**CITY OF LA VISTA
PLANNING DIVISION**

RECOMMENDATION REPORT

CASE NUMBER: 2015-PUD-02

GOOD NEIGHBOR SENIOR LIVING

C3.0

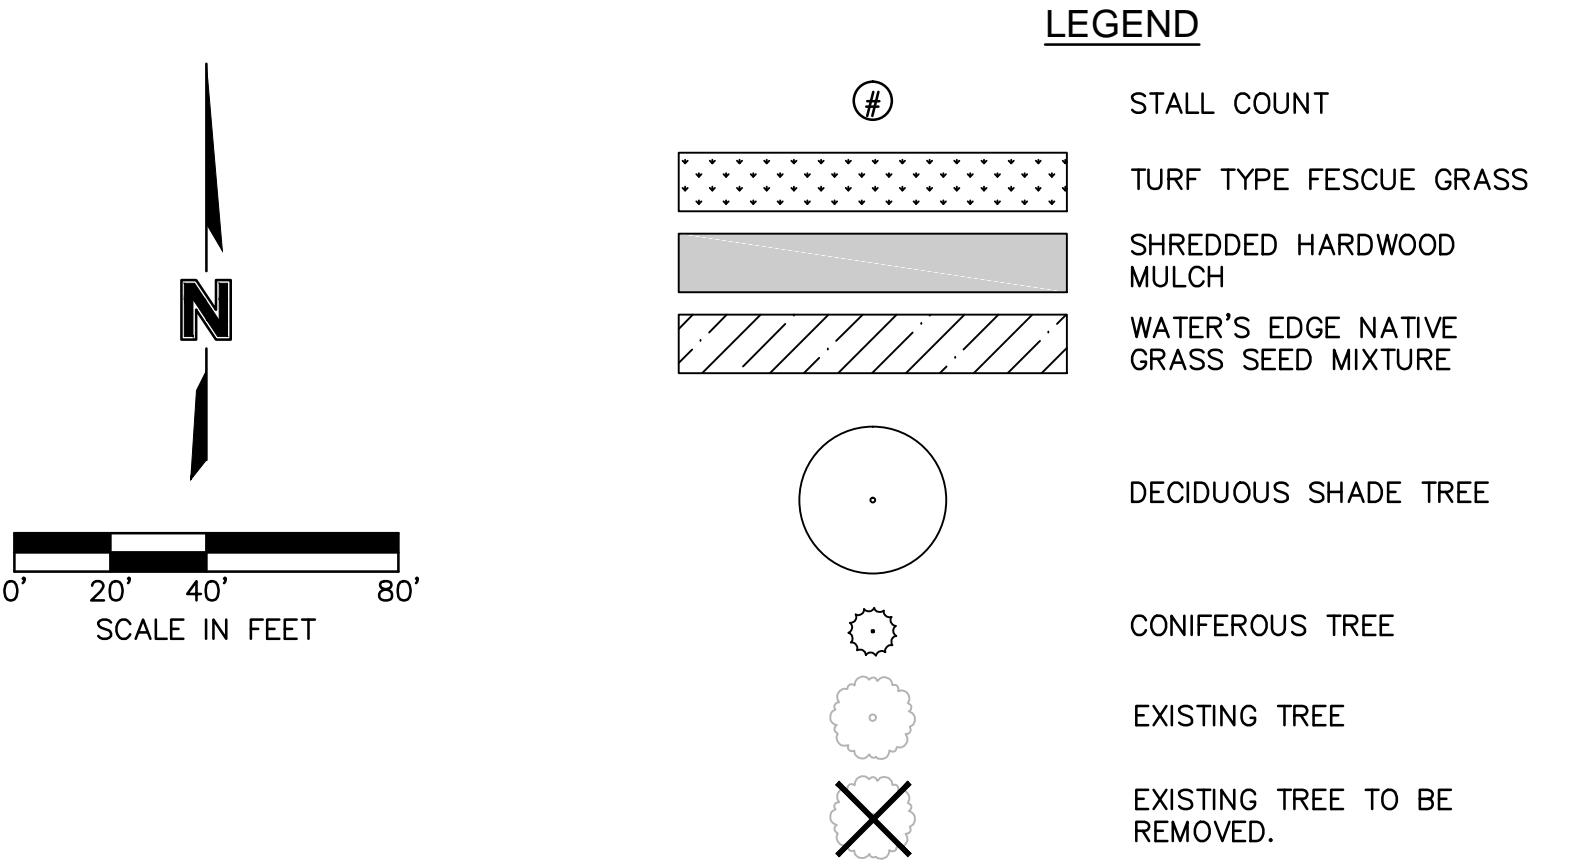
F. LANDSCAPING: The property is within the Gateway Corridor Overlay District – Sub Area Secondary Overlay and is subject to design review. Also, an existing permanent 30-foot wide landscape buffer easement lies along the northern edge of the Mayfair commercial area. This easement is depicted in the northwest corner of the property on the Preliminary PUD Site Plan map.

A draft landscaping plan has been submitted with the Preliminary PUD Site Plan map set. This plan is still under review however review will be significantly complete prior to Planning Commission review of the Conditional Use Permit (the next step in the approval process), to which the landscaping plan will be an exhibit.

Staff recommends approval of the Preliminary PUD Site Plan map contingent on the finalization of the landscaping plan prior to City Council approval of the Final PUD Plan.
